RE: CHANGE ORDER NO. 1
EDWARD A. DUFRESNE COMMUNITY CENTER CHILLER REPLACEMENT/UPGRADE
(PROJECT NO. GB240701)

CHANGE ORDER

No. 01 (Final)

Project: Edward A. Dufresne Community Center Chiller Replacement/Upgrade

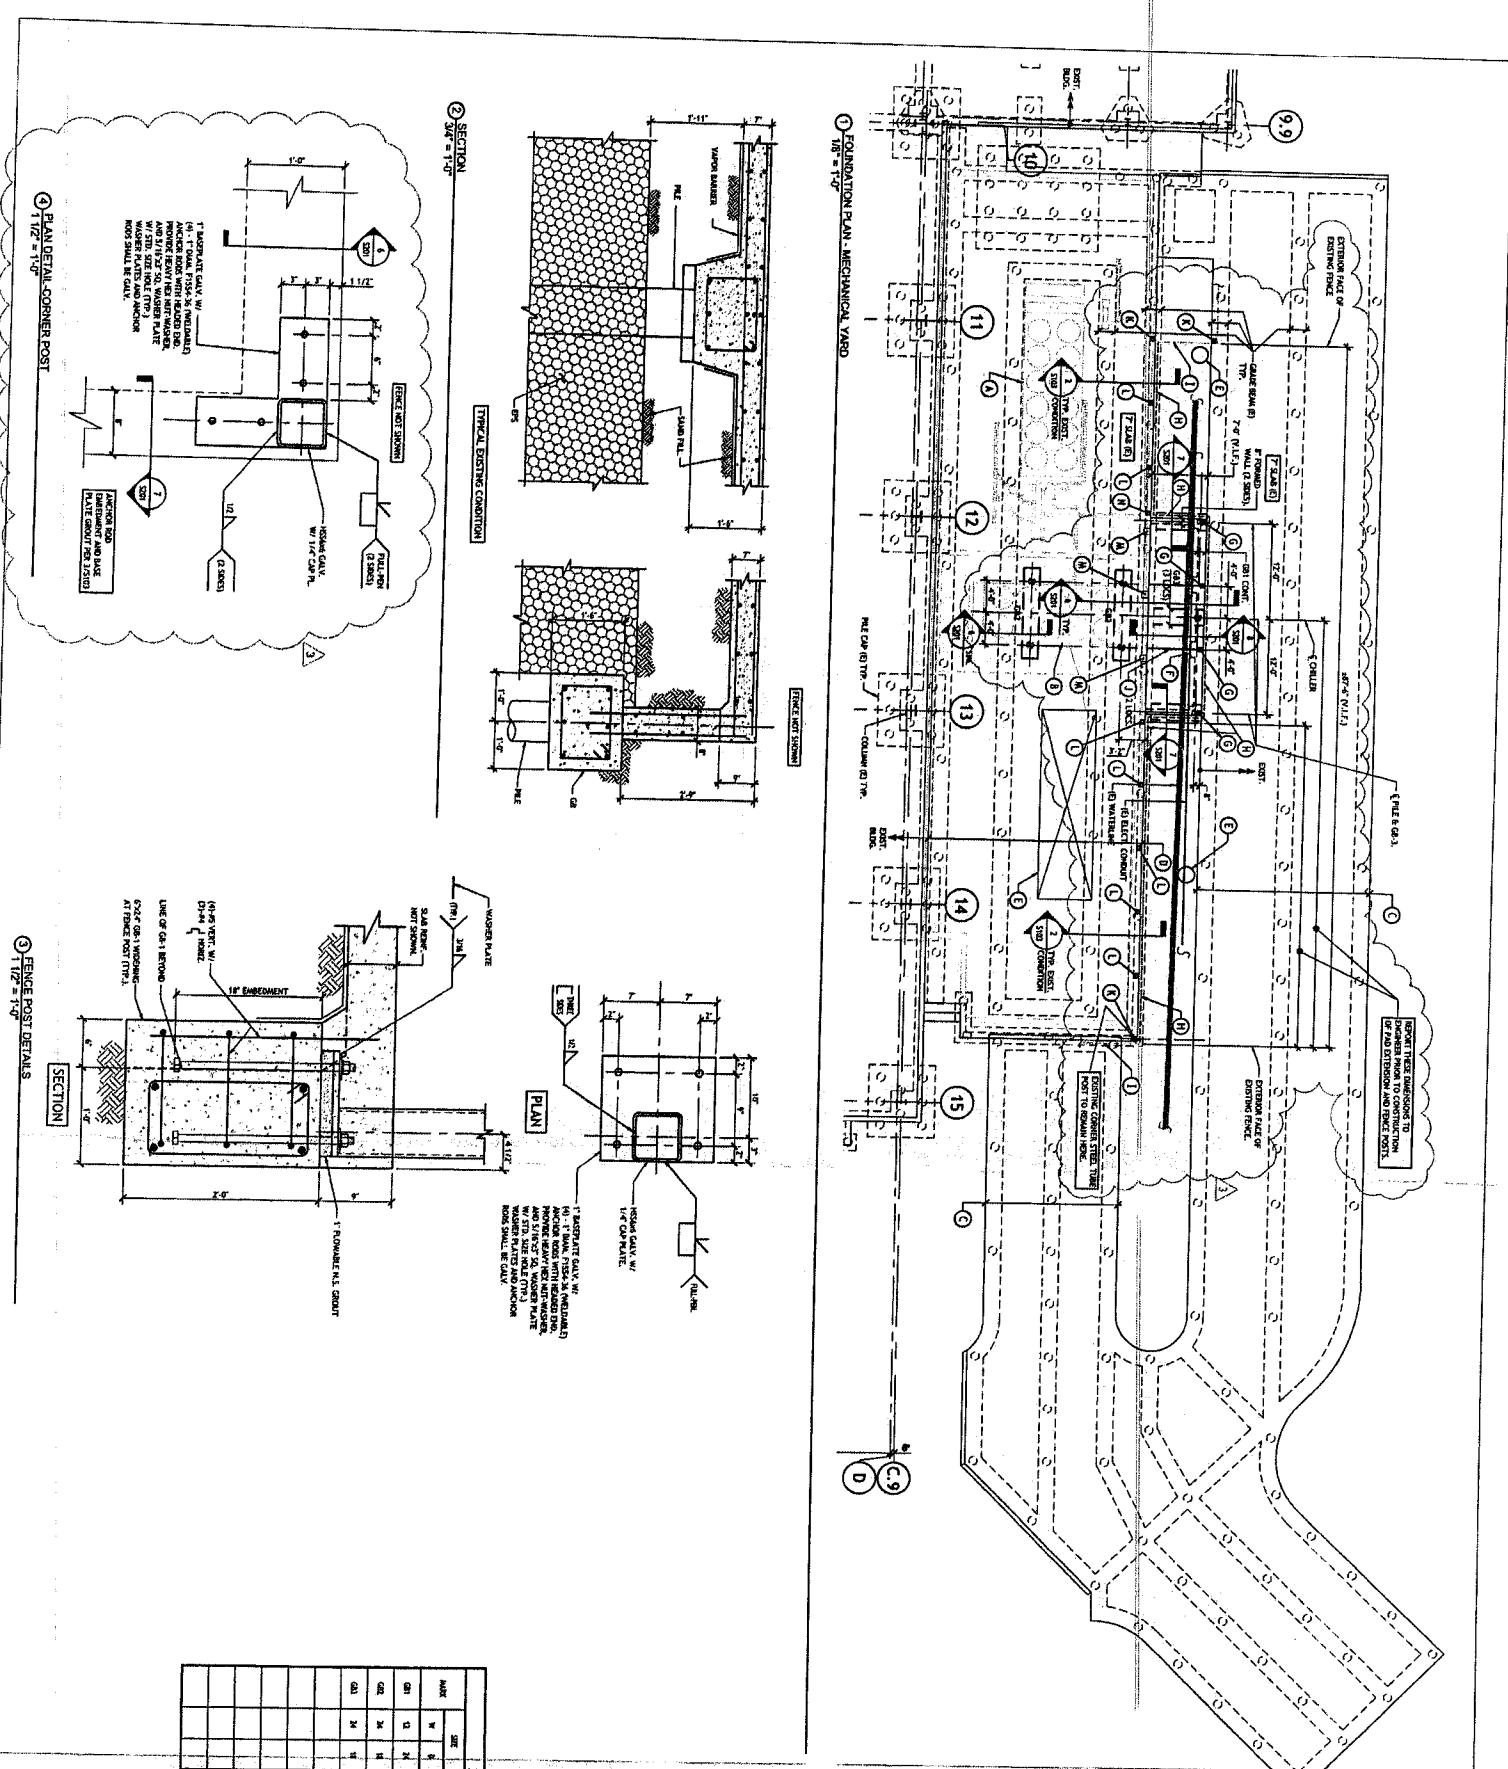
- a. Contract Item #1: Credit for Scope revisions related to RFI #01 and revised S103 dated 8/13/2025.
Piles reduced from (13) piles to (7) piles and reduction in concrete scope. Drill and epoxy new fence post anchor bolts at existing slab pockets. Additional days for delays
The quantity is to be changed to *define quantity and units. (-\$30,990.93)*

- a. Concrete and piles scope of work was reduced due to location of existing underground pipe to allow for better access for future repairs as needed.
